*DOCUMENT NO:* OP-1903.066

*TITLE:* EMERGENCY RESPONSE FACILITY -  
OPERATIONAL SUPPORT CENTER (OSC)

*CHANGE NO:* PC-01

**ENTERGY OPERATIONS INCORPORATED  
ARKANSAS NUCLEAR ONE**

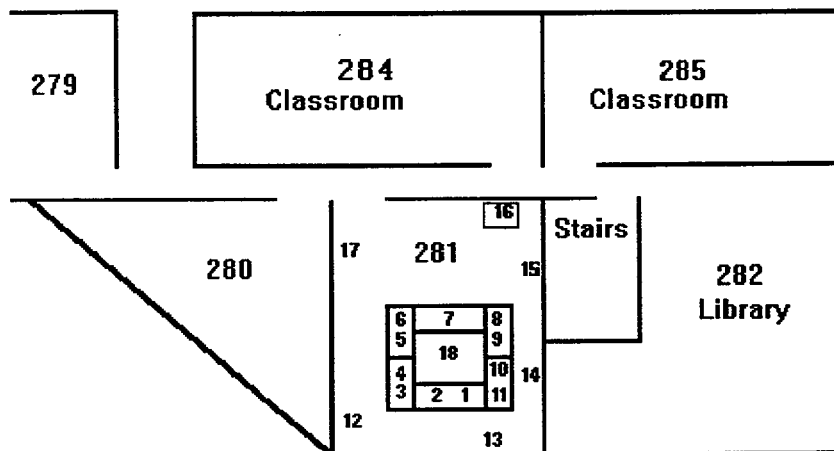
| AFFECTED SECTION:<br>(Include step # if applicable)<br><br>Position Guide<br>Task C-1<br><br>1903.066 A | DESCRIPTION OF CHANGE: (For each change made, include sufficient detail to describe reason for the change.)<br><br>Added steps for use of cordless headset.<br><br>Changed layout of OSC for ease in seeing the Team Tracking Board. |
